Re: EB-2021-0110 Hydro One Networks Inc. 2023-2027 Joint Transmission & Distribution Rate Application
AMPCO's Interrogatories

**Application for electricity transmission and distribution
rates and other charges for the period
from January 1, 2023 to December 31, 2027**

AMPCO Interrogatories October 26, 2021

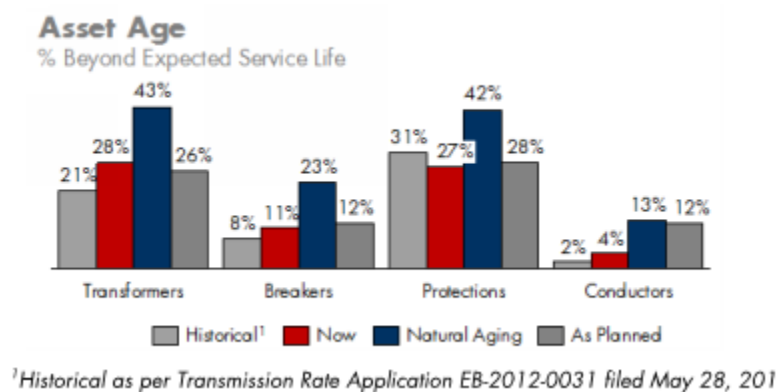
The 2019-2024 Business Plan from the last proceeding states “Based on Hydro One’s assessment of its transmission system, a significant portion of the assets are reaching the end of their expected service life (ESL) and have deteriorated to the point where investment is required to maintain customer reliability and meet safety and environmental sustainability requirements. Through natural aging, it is forecast that 43% of transformers, 23% of breakers, 42% of protection systems, and 13% of conductors will reach their ESL over the next six years, as shown in the figure following. This evolving age profile is largely due to the significant system development in the 1950s and 1960s; these assets now require replacement.

Please complete the following table regarding assets beyond their ESL at the end of 2017:

Figure 2 - Delivery Point Interruptions Related to Equipment (2008 through 2017)

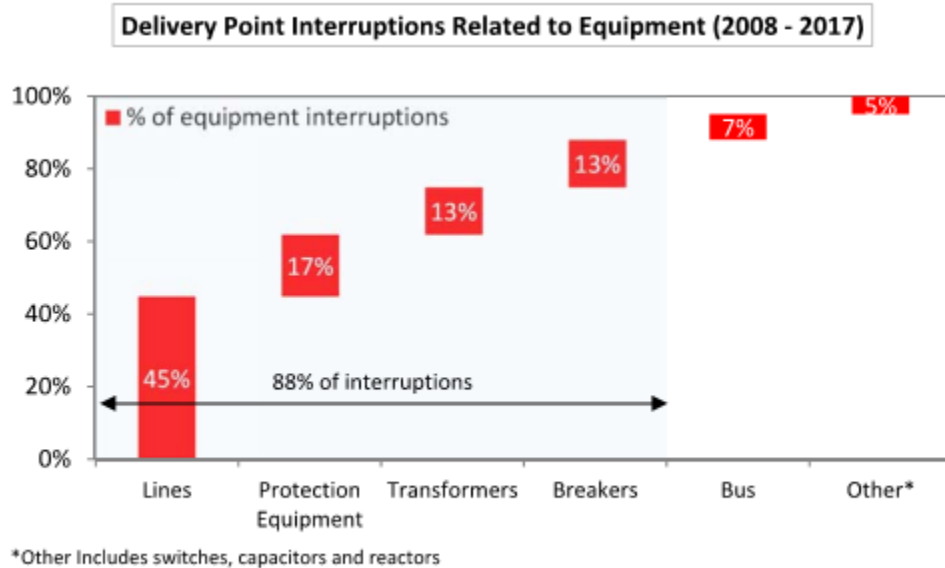
a) Please complete the delivery point interruptions related to equipment (%) for the following assets:

b) Please provide a further breakdown of the data for the assets under Lines.
